SKILLING, HELLE, CHRISTIANSEN, ROBERTSON — Structural & Civil Engineers

PROJECT: THE WORLD TRADE CENTER | TITLE: STRENGTHENING OF BEAM TO GIRDER CONNECTION | DATE: 10-17-69

(Change No. 503.100)

PART PLAN AT EL. 310

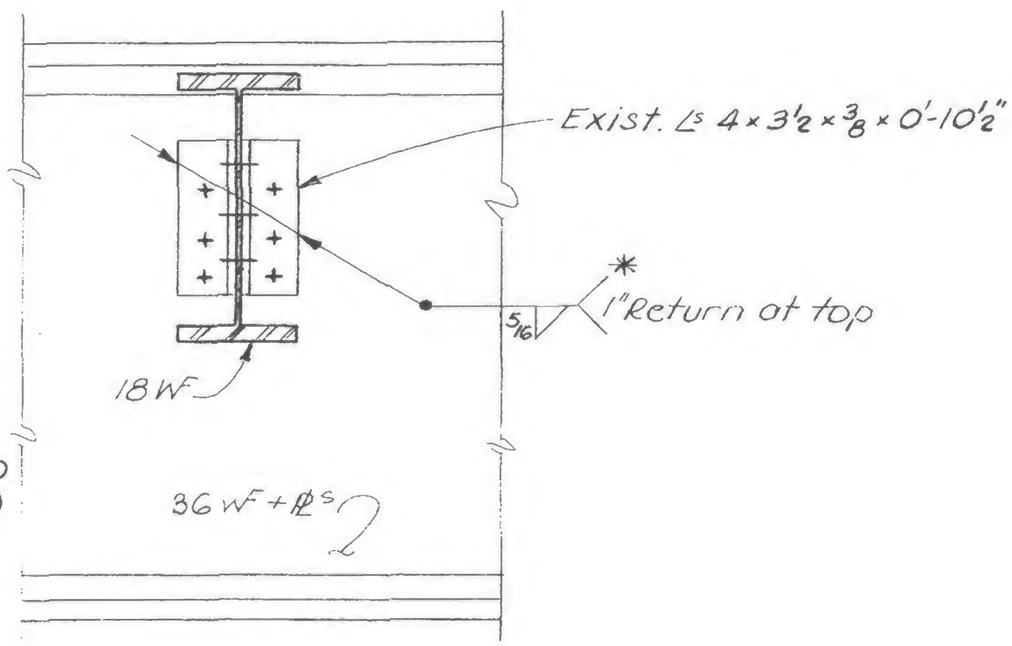
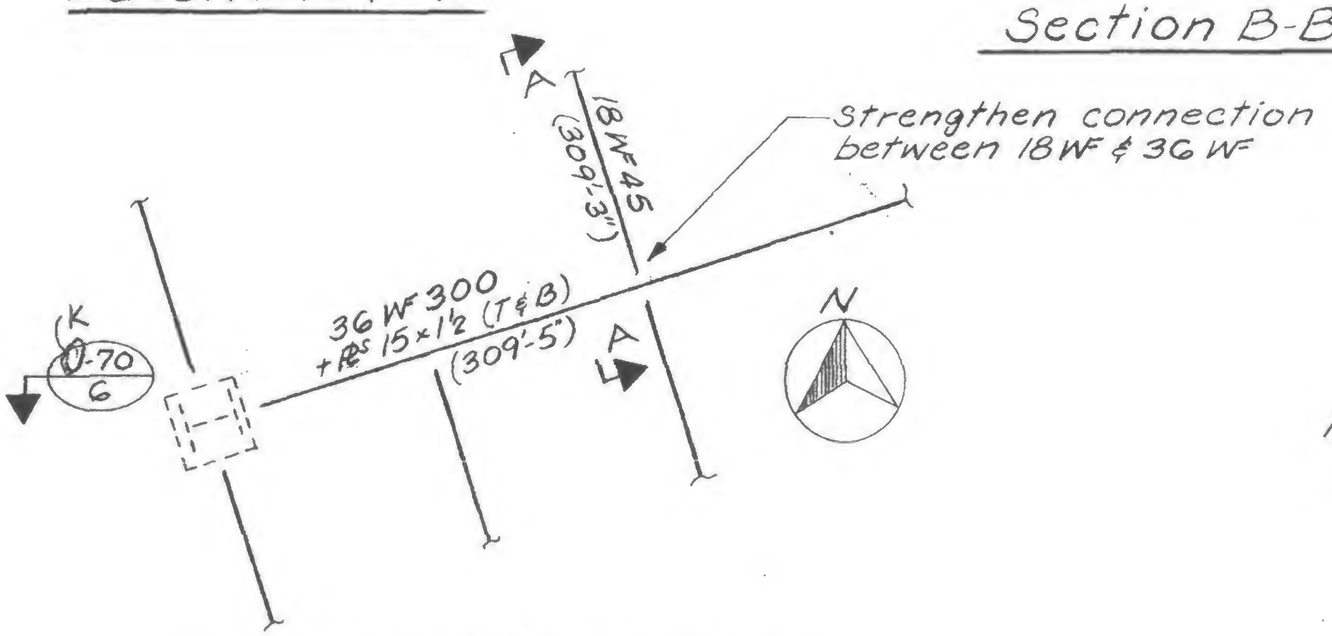
Due to widening of work-platform to 52'-0" ——— North of Tower 'B'

1. * — added welding
2. All welds to be E70xx
